PLANNING APPROVAL,
PLANNED UNIT DEVELOPMENT &
SUBDIVISION STAFF REPORT

| <u>NAME</u> | Lone Oak Properties, LLC |
| <u>SUBDIVISION NAME</u> | Lone Oak Subdivision |
| <u>LOCATION</u> | 911 Dauphin Street (Southeast corner of Lebaron Street and Dauphin Street, extending South to Conti Street) |

SITE PLAN

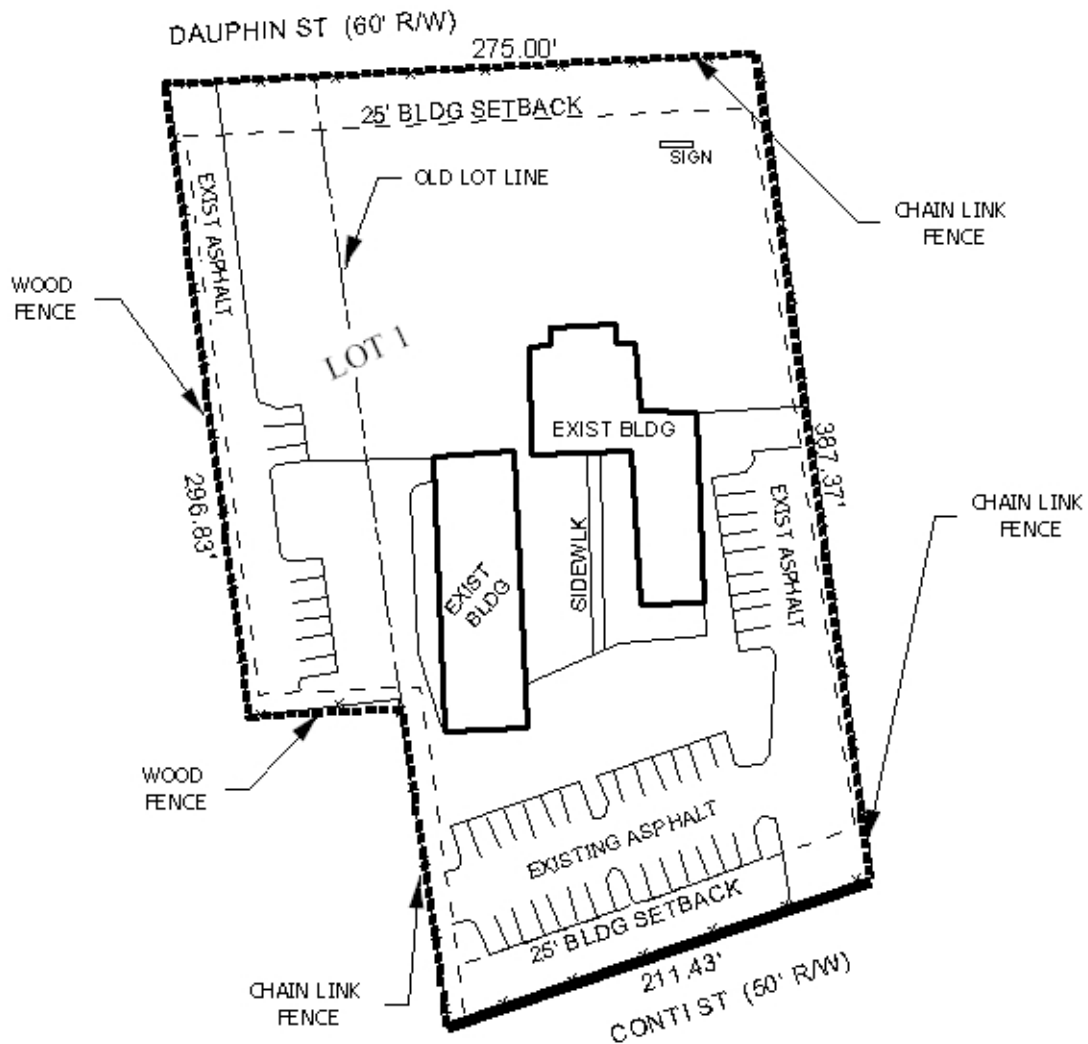
Access management is a concern because the property has frontage on two streets, including a proposed major street. The site plan depicts one curb-cut onto Dauphin Street and one curb-cut onto Conti Street. The site should be limited to the curb-cuts depicted on the site plan, thus a note should be placed on the final plat, if approved, stating that the site is limited to one curb-cut onto Dauphin Street and one curb-cut onto Conti Street, with the size, design and location to be approved by Traffic Engineering and conform, if possible, with AASHTO standards.

The site plan depicts a parking layout that reduces the existing paved area. The new parking layout will not allow traffic to circulate across the site, from Dauphin Street to Conti Street, which should eliminate any potential cut-through traffic.

The site plan also shows an increase in landscaping that includes frontage trees and vegetative buffering where the site abuts residential uses. It is recommended that the vegetative buffer where the site abuts residential uses be augmented with a 6-foot high wooden privacy fence (except for the portion of the fence within the 25-foot setback line, which can only be 3-feet tall), in conformance with Section 64-4.D. of the Zoning Ordinance.

The site plan does not show any new sidewalks within the site, nor any sidewalk connections from the existing structures to the sidewalks on Dauphin and Conti Streets. It is recommended that the site plan be revised to show on-site pedestrian circulation and connections to existing sidewalks on abutting streets.

Finally, there is no indication on the site plan as to the proposed location of any dumpster or other waste storage facility. If the applicant utilizes a dumpster, the location of the storage area for the dumpster must be indicated on the site plan, and the location and required screening must comply Section 64-4.D.9. of the Zoning Ordinance, as well as with all other applicable regulations.

Planning Approval: The request is recommended for Approval, subject to the following conditions: 1) use of the site for housing shall be limited to documented university students working / interning at the Riverview and Battle House Hotels; 2) revision of the site plan to additionally depict a 6-foot high wooden privacy fence where the site abuts residential uses to the Southwest; 3) revision of the site plan to depict sidewalks on the site and linking to existing sidewalks along Dauphin and Conti Streets; 4) revision of the site plan to depict any dumpster storage facility, in compliance with Section 64-4.D.9. of the Zoning Ordinance; 5) placement of a note on the site plan stating that on-site lighting must fully comply with Sections 64-4.A.2. and 64-6.A.3.c. of the Zoning Ordinance; 6) placement of a note on the site plan / plat stating that the site is limited to one curb-cut onto Dauphin Street and one curb-cut onto Conti Street, with the size, design and location to be approved by Traffic Engineering and to comply, if possible, with AASHTO standards; 7) placement of a note on the site plan stating the following: *"Property to be developed in compliance with state and local laws that pertain to tree preservation and protection on both city and private properties (State Act 61-929 and City Code Chapters 57 and 64). Preservation status is to be given to the 80" Live Oak Tree located on the North side of Lot 1 and the 60" Live Oak Tree located on the West side of Lot 1. Any work on or under this tree is to be permitted and coordinated with Urban Forestry; removal to be permitted only in the case of disease or impending danger."* 8) completion of any approvals required from the Architectural Review Board for building renovations and site improvements; 9) provision of a revised site plan to the Planning Section of Urban Development prior to the signing of the final subdivision plat; 10) completion of the Subdivision process; and 11) full compliance with all other municipal codes and ordinances.

Planned Unit Development: The request is recommended for Approval, subject to the following conditions: 1) use of the site for housing shall be limited to documented university students working / interning at the Riverview and Battle House Hotels; 2) revision of the site plan to additionally depict a 6-foot high wooden privacy fence where the site abuts residential uses to the Southwest; 3) revision of the site plan to depict sidewalks on the site and linking to existing sidewalks along Dauphin and Conti Streets; 4) revision of the site plan to depict any dumpster storage facility, in compliance with Section 64-4.D.9. of the Zoning Ordinance; 5) placement of a note on the site plan stating that on-site lighting must fully comply with Sections 64-4.A.2. and 64-6.A.3.c. of the Zoning Ordinance; 6) placement of a note on the site plan / plat stating that the site is limited to one curb-cut onto Dauphin Street and one curb-cut onto Conti Street, with the size, design and location to be approved by Traffic Engineering and to comply, if possible, with AASHTO standards; 7) placement of a note on the site plan stating the following: *"Property to be developed in compliance with state and local laws that pertain to tree preservation and protection on both city and private properties (State Act 61-929 and City Code Chapters 57 and 64). Preservation status is to be given to the 80" Live Oak Tree located on the*

Subdivision: The Subdivision request is recommended for Tentative Approval, subject to the following conditions: 1) revision of the plat to show the minimum building setback line adjusted to reflect a future right-of-way width of Dauphin Street of 50 feet, as measured from the centerline, per Section V.D.9. of the Subdivision Regulations; 2) placement of a note on the plat stating that the site is limited to one curb-cut onto Dauphin Street and one curb-cut onto Conti Street, with the size, design and location to be approved by Traffic Engineering and to comply, if possible, with AASHTO standards; 3) placement of a note on the plat stating the following: *"Property to be developed in compliance with state and local laws that pertain to tree preservation and protection on both city and private properties (State Act 61-929 and City Code Chapters 57 and 64). Preservation status is to be given to the 80" Live Oak Tree located on the North side of Lot 1 and the 60" Live Oak Tree located on the West side of Lot 1. Any work on or under this tree is to be permitted and coordinated with Urban Forestry; removal to be permitted only in the case of disease or impending danger."*; and 4) full compliance with all other municipal codes and ordinances.
